Product Change Notification (PCN)

PCN #: 10G-2026 *Date: October 15th, 2026*

Ezurio Part Number	Description	Current REV	New REV
N8MP_SMARC_SOM_2r16e	Nitrogen8M PLUS SMARC: i.MX8M Quad Plus / 2GB / 16GB eMMC	2-1	2-2
N8MP_SMARC_SOM_2r16e_i	Nitrogen8M PLUS SMARC: i.MX8M Quad Plus / 2GB / 16GB eMMC / -40 to +85°C	2-1	2-2
N8MP_SMARC_SOM_4r16e	Nitrogen8M PLUS SMARC: i.MX8M Quad Plus / 4GB / 16GB eMMC	2-1	2-2
N8MP_SMARC_SOM_4r16e_i	Nitrogen8M PLUS SMARC: i.MX8M Quad Plus / 4GB / 16GB eMMC / -40 to +85°C	2-1	2-2
N8MP_SMARC_SOM_8r16e	Nitrogen8M PLUS SMARC: i.MX8M Quad Plus / 8GB / 16GB eMMC	2-1	2-2
N8MP_SMARC_SOM_8r16e_i	Nitrogen8M PLUS SMARC: i.MX8M Quad Plus / 8GB / 16GB eMMC / -40 to +85°C	2-1	2-2
N8MP_SMARC_SOM_2r16e_NX611_1M	Nitrogen8M PLUS SMARC: i.MX8M Quad Plus / 2GB / 16GB eMMC / NX611	2-1	2-2
N8MP_SMARC_SOM_2r16e_NX611_1M_i	Nitrogen8M PLUS SMARC: i.MX8M Quad Plus / 2GB / 16GB eMMC / NX611 / -40 to +85°C	2-1	2-2
N8MP_SMARC_SOM_4r16e_NX611_1M	Nitrogen8M PLUS SMARC: i.MX8M Quad Plus / 4GB / 16GB eMMC / NX611	2-1	2-2

6.1 Designator D1

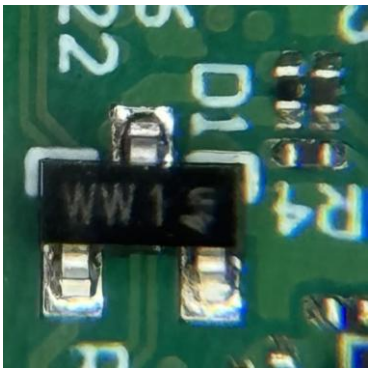
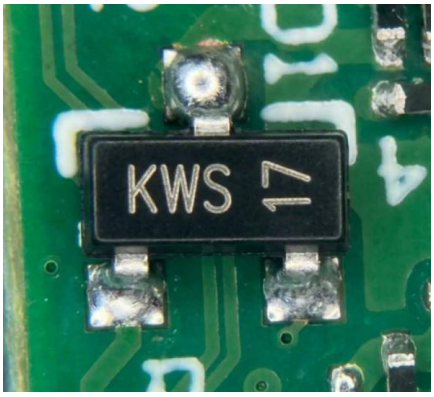
Replace the existing BAT54C with a lower-forward-voltage Schottky diode. SDM40E20LC-7 provides lower forward-voltage drop compared with the existing BAT54C, improving the voltage available on the downstream NVCC_BBSM_1V8 rail.

The board shows reset/startup reliability issues below -10°C. Investigation indicates that the voltage drop across the existing BAT54C diode reduces the effective NVCC_BBSM_1V8 voltage. This can reduce the high-level margin for PMIC_RST_B.

- Old part: BAT54CLT1G (Text on the diode: WW1)

- New part: SDM40E20LC-7 (Text on the diode: KWS)
